**RELM Wireless Corp. – BK Radio**  
7100 Technology Dr.  
W. Melbourne, FL 32904

### **K95KNGP400 Class II Permissive Change Request – Circuit Change Description**

Applicant: RELM Wireless Corporation  
FCC ID: K95KNGP400

Figure 2 – Transmitter with Changes to Support Emissions Designator 8K10F1W

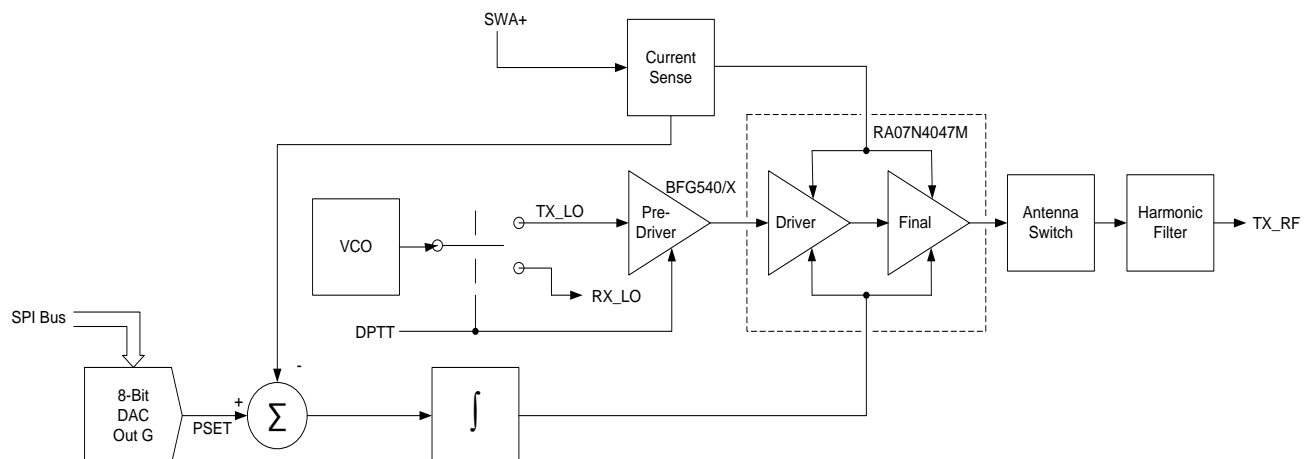
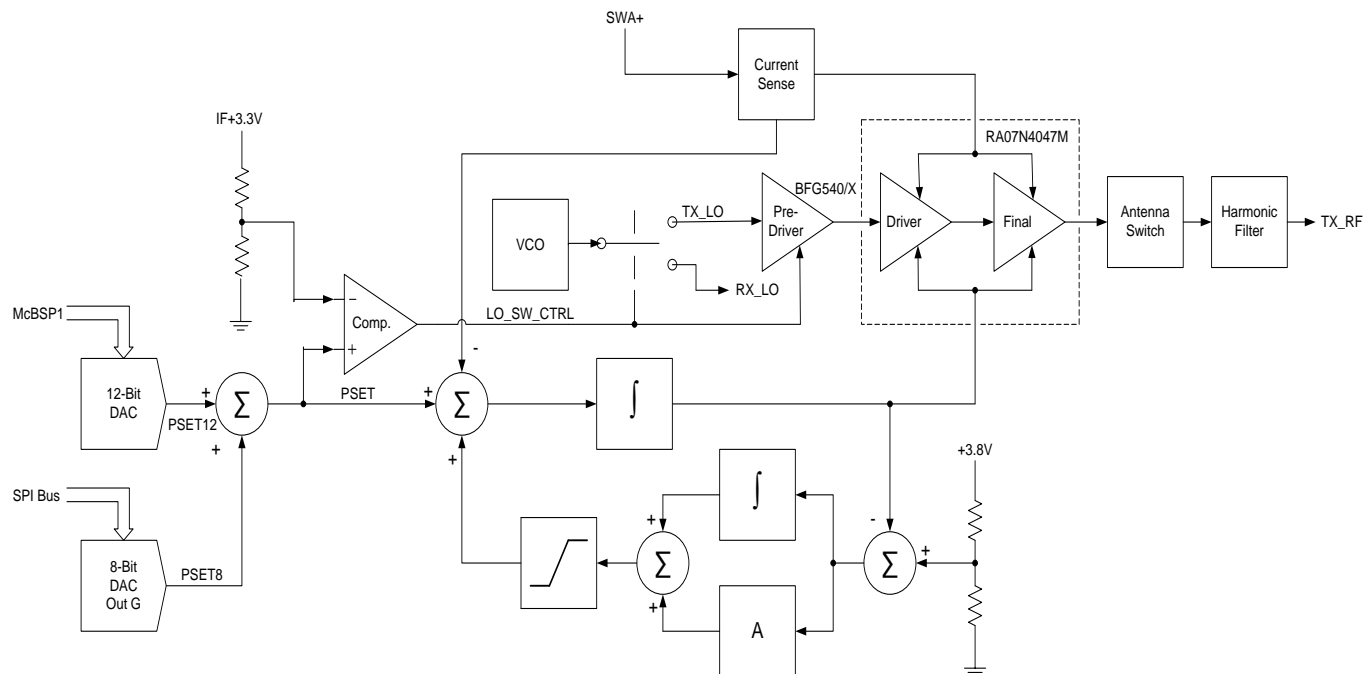
Some changes to the transmitter power control circuitry are required in order to support the more accurate power ramping required for P25 Phase II operation (emissions designator 8K10F1W). These changes consist of: the addition of a 12-bit DAC to set power, the addition of a comparator to control the existing RX/TX LO switch, and the addition of a secondary control loop to maintain a resistor divider determined offset on the driver and final gate voltages during the off slot. Figure 1 below shows a block diagram of the transmitter as it was when the K95KNGP400 type acceptance was granted and Figure 2 shows a block diagram of the transmitter with the changes required to support emissions designator 8K10F1W. No changes have been made to the synthesizer, VCO, pre-driver stage, PA module, antenna switch, or harmonic filter. None of the changes will affect maximum output power.
